**Major Project 10\_0076  
'Kirrawee Brick Pit' Concept Plan  
566 – 594 Princes Highway, Kirrawee**

**Response to Submissions &  
Preferred Project Report**

**November 2011**

**Figure 2: Excerpt from Plan Ref: 0120 prepared by Woodhead Architects**

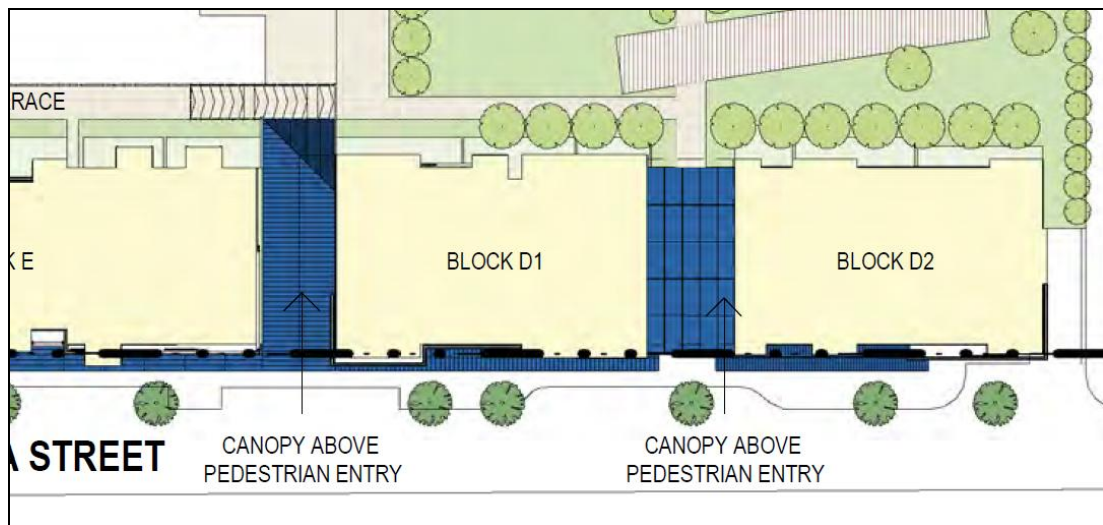
*“Concern is raised regarding the length of the proposed building envelopes fronting Flora Street. Consideration should be given to reducing/splitting the building envelopes to reduce the built form and provide greater articulation”*

This change in length, along with further articulation to the buildings along Flora Street will ensure that the scale of the buildings along Flora Street relate better to the scale and grain on the opposite side of Flora Street.

Refer to the extract from Plan Ref: 0120 provided below and **Section 4** of the PPR for further discussion on this issue.

**Figure 6: Excerpt from the original (top) and amended (bottom) Building Height Plan – prepared by GMU**

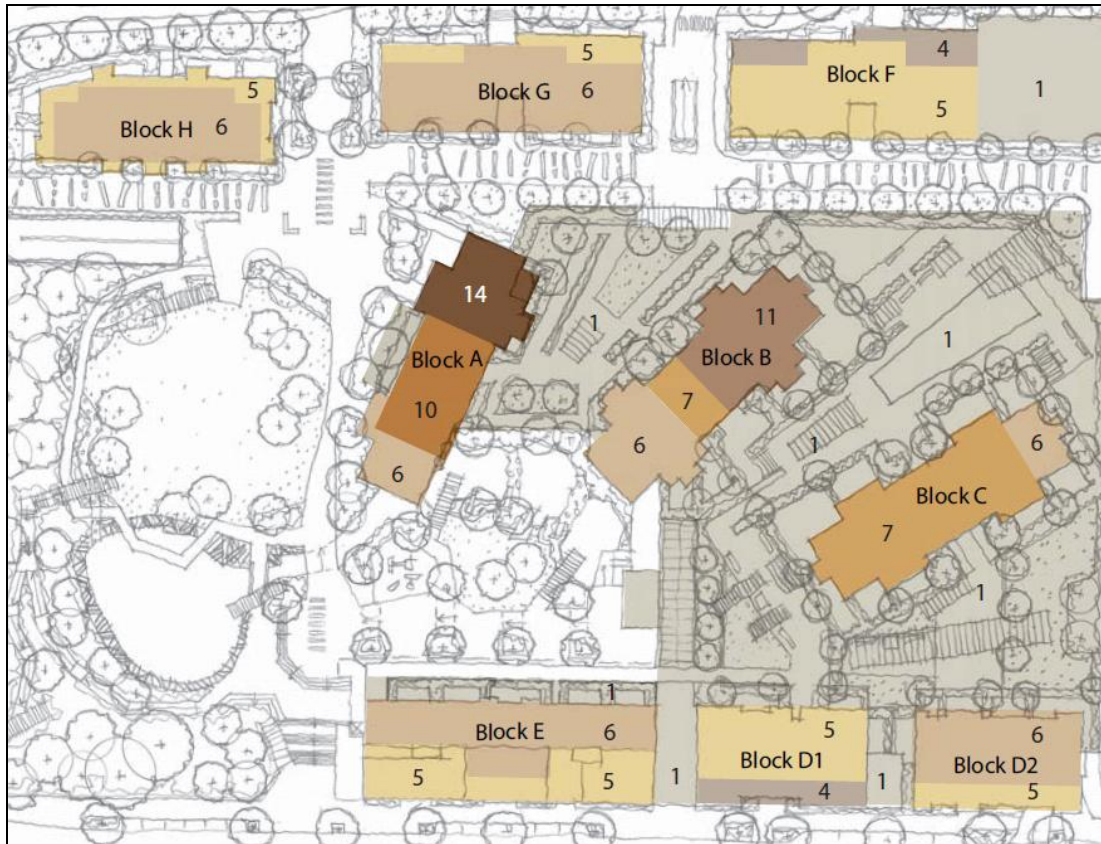
*"Concern is raised regarding the height of the proposed central towers, particularly Block A. Reducing the height of the proposed central towers should be considered within the PPR response. The PPR should also provide further justification of the proposed height of the central towers with regard to Council policy and the Metropolitan Plan for Sydney 2036".*

In response to the D&PI's concerns in relation to the height of the proposed central towers, the overall height of Block A has been reduced by one (1) level to 14 levels and mid-rise

levels have been removed from the middle of Blocks A and B. This is detailed on the extract from the original and revised GUM Urban Design Reports provided at **Figure 6** in **Section 4** of the PPR.

The amended building heights are detailed on the extracts from the original and revised Urban Design Report below:
